Interactive comment on “The AquaVIT-1 intercomparison of atmospheric water vapor measurement techniques” by D. W. Fahey et al.

Anonymous Referee #2 Received and published: 24 July 2014 The manuscript as written discusses an important ground facility based blind intercomparison activity held at the AIDA chamber in Karlsruhe, Germany. In this intercomparison, many different instruments were intercompared, including a "core" set which have extensive heritage and experience measuring water vapor in the UT/LS and TTL, from airborne platforms. The impetus for this intercomparison was, in large measure, the large disagreements among these instruments in prior airborne campaigns. One primary result of the intercomparison study, reported for the first time in this manuscript, is that the differences observed in flight cannot be explained by the performance in the lab setting at the AIDA

Fig. 1.

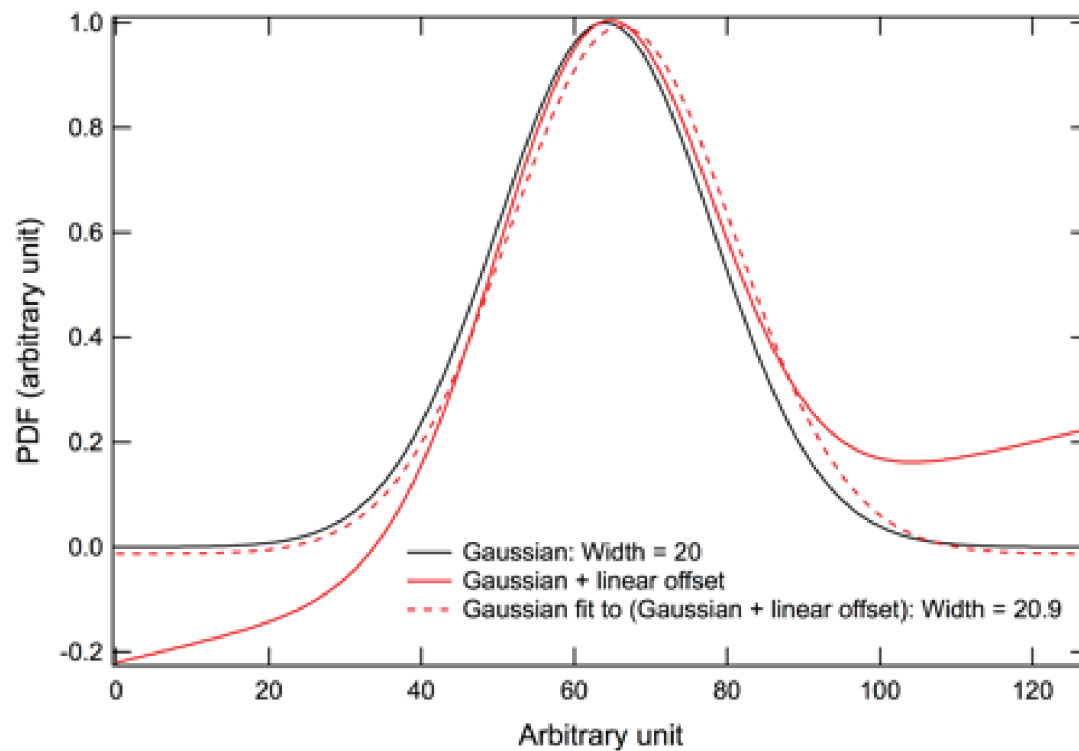
Regarding the collective reference method, the method for determining precision is not as clear as it could be. At the end of section 6.2 (in subsections d and e) a method is described which uses the ensemble mean slope vs time as a reference. From the difference between an individual instrument's measurement during that segment and the ensemble mean, one would expect to see a contribution not only from the Gaussian width of the distribution but also from the varying offset (unless all slopes are the same). This additional difference can't, in general, be lumped into the Gaussian, but it is not clear how the authors handled that time-varying offset. The actual equation used is given in the caption for Figure 4 and it doesn't seem to include the offset. I suggest making these sub-sections more clear and perhaps inserting the appropriate equation(s) in the main text body.

We agree that the difference Gaussian derived from an individual instrument time series and the ensemble mean time series for a segment could be skewed if the former has a significantly different mean slope compared to the ensemble reference. This possibility, already mentioned in Section 6.2e, albeit not clearly, could occur if one of

the core instruments is not performing well. Mathematically, this situation represents an additional linear term added to a true probability distribution function. Calculations show that the error in the Gaussian width is less than 5% as long as the amplitude of the linear offset is less than about 40% of the Gaussian peak height. The figure below shows an example for a 40% offset, which causes a very visible difference in the PDF but only a 5% change in the width. A linear offset of 40% is much larger than observed for any instrument time series.

See attached figure

The caption of Figure 8 now includes the clarification:

“The symmetry in the Gaussian fits for each instrument indicates that the mean slopes comprising the ensemble mean are similar and, hence, slope differences do not significantly affect the Gaussian widths.”
